TOWN OF MILFORD, NH OFFICE OF COMMUNITY DEVELOPMENT

STAFF MEMORANDUM

Project: Jessica Hudson for the properties located at Tax Map 43, Lots 24 and 25, Tonella Road. Public

Subdivision Plan Tonella Hill Townhomes

TONELLA ROAD
EXTENSION
PLAN & PROFILE

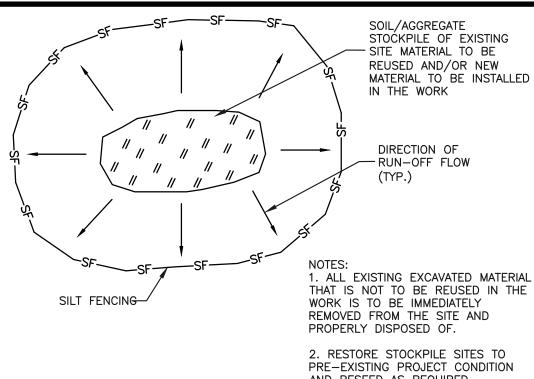
1. Sheet 5 of 9. The applicant should explain how snow will be managed. Given the length of the proposed roadway extension and type of development, it is questionable whether there is sufficient designated snow storage areas shown on the plan. Please explain.

- 2. **Sheet 5 of 9.** Notes 17 and 22 are the same. Please delete one and renumber accordingly. *Addressed*.
- 3. **General Comment, Turn-around Design and Lot Layout.** Please explain what alternatives were considered regarding the roadway layout and turnaround design and location of the 4 unit multi-family townhouse. More specifically, could the tomahawk design be reversed to provide additional usable outdoor living space/passive recreation areas for the 4 unit multi-family townhouses and/or relocation of the proposed building away from the sloped areas?

Addressed. The topic of snow management was discussed at the last Board meeting. Based on discussions it appears the Board was content with the feedback provided by the DPW Director and the discussion of how the snow will be managed. Additionally, the snow removal note (Note 10) was clarified on the site plan. Staff finds that the applicant has addressed the concerns raised. However, the applicant should address any/all remaining concerns expressed by the Board.
